Amendments to the Drawings:

REMARKS/ARGUMENTS

Figure 1 is a block diagram of a super-heterodyne radio receiver.

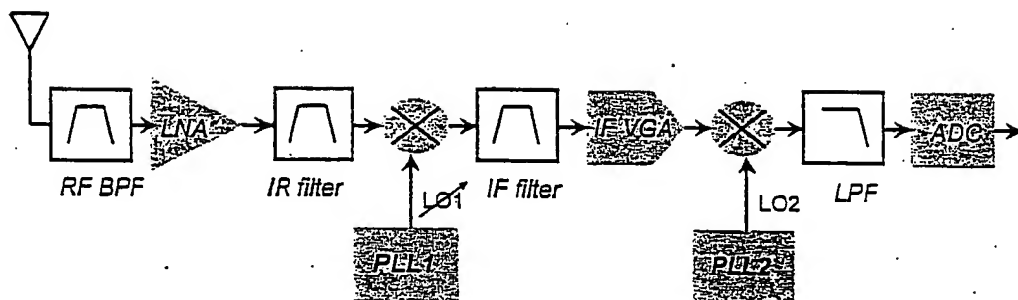
The attached drawings includes changes to Figures 1-7. These sheets, which includes Fig. 1-7, replaces the original sheets including Figures 1-7. Figures 1-7 have been amended to delete descriptions after the figure numbers. Annotated sheets showing the changes made are attached hereto.

Figure 6 is a block diagram of a DDS circuit which generates a second LO signal in accordance with one embodiment of the present invention.

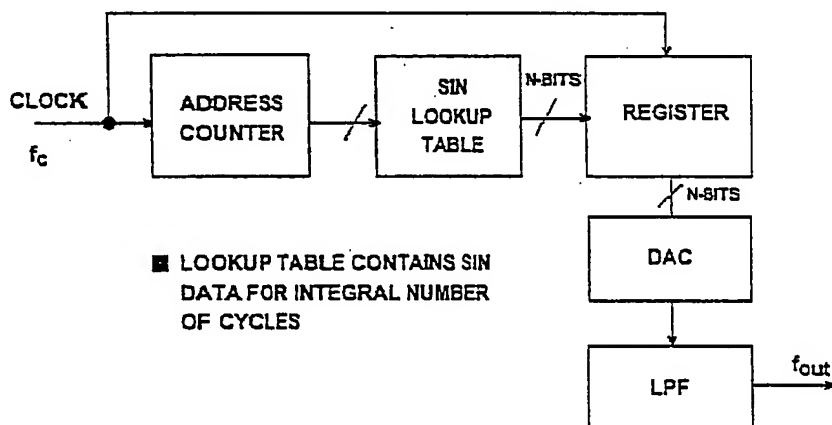
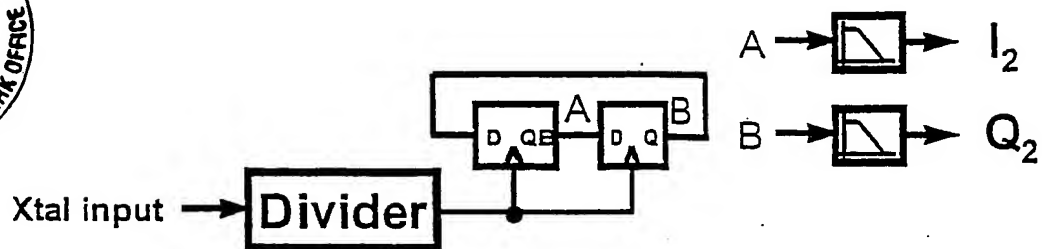
~~Figure 7 is a block diagram of another circuit which may be used to generate a second I/O signal in accordance with the present invention.~~
